Project	IEEE 802.16 Broadband Wireless Access Working Group < http://ieee802.org/16 >	
Title	Chase H-ARQ support for all FEC schemes	
Date Submitted	2004-06-25	
Source(s)	Mark Cudak, Brian Classon, Motorola Inc. Valentine J. Rhodes, Intel Corporation	Mark.Cudak@motorola.com Brian.Classon@motorola.com valentine.j.rhodes@intel.com
Re:	Ballot #14a	
Abstract	This contribution proposes text to allow recently defined features such as H-ARQ and AMC sub channels to operate with all FEC schemes.	
Purpose	Adoption	
Notice	This document has been prepared to assist IEEE 802.16. It is offered as a basis for discussion and is not binding on the contributing individual(s) or organization(s). The material in this document is subject to change in form and content after further study. The contributor(s) reserve(s) the right to add, amend or withdraw material contained herein.	
Release	The contributor grants a free, irrevocable license to the IEEE to incorporate material contained in this contribution, and any modifications thereof, in the creation of an IEEE Standards publication; to copyright in the IEEE's name any IEEE Standards publication even though it may include portions of this contribution;

Figure 130—Construction of H-ARQ encoder packet

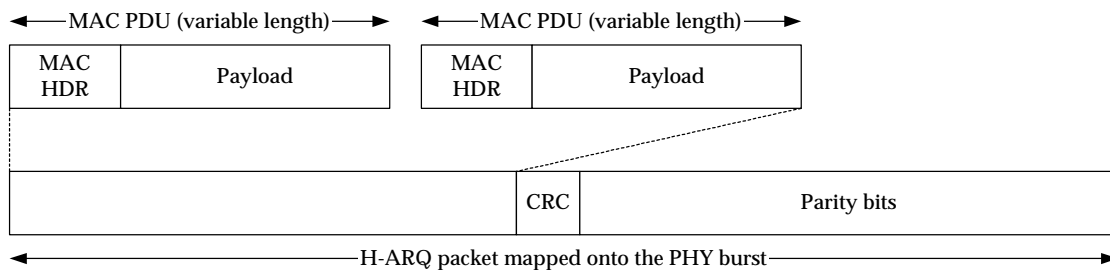
Modify Section 6.3.17 "MAC support for HARQ" after figure 130

[The two main variants of H-ARQ are supported, Chase Combining or Incremental Redundancy \(IR\). For IR, the PHY layer will encode the H-ARQ packet generating several versions of encoded subpackets. Each subpacket will be uniquely identified using a subpacket identifier \(SPID\). For Chase Combining, the PHY layer will encode the H-ARQ packet generating only one version of the encoded packet. As a result, no SPID is required for Chase Combining.](#)

~~Each H-ARQ packet is encoded according to the PHY specification, and four subpackets are generated from the encoded result. A subpacket identifier (SPID) is used to distinguish the four subpackets. In case of downlink communication, a BS can send one of the subpackets in a burst transmission. Because of the redundancy among the subpackets, SS can correctly decode the original encoder packet even before it receives all four subpackets. Whenever receiving the first subpacket, the SS attempts to decode the original encoder packet from it. If it succeeds, the SS sends an ACK to the BS, so that the BS stops sending additional subpackets of the encoder packet. Otherwise, the SS sends a NAK, which causes the BS to transmit one subpacket selected from the four. These procedures go on until the SS successfully decodes the encoder packet. When the SS receives more than one subpacket, it tries to decode the encoder packet from ever received subpackets.~~

[For downlink H-ARQ operation, the BS will send a version of the encoded H-ARQ packet. The SS will attempt to decode the encoded packet on this first H-ARQ attempt. If the decoding succeeds, the SS will send an ACK to the BS. If the decoding fails, the SS will send a NAK to the BS. In response, the BS will](#)

send another H-ARQ attempt. The BS may continue to send H-ARQ attempts until the SS successfully decodes the packet and sends an acknowledgement.
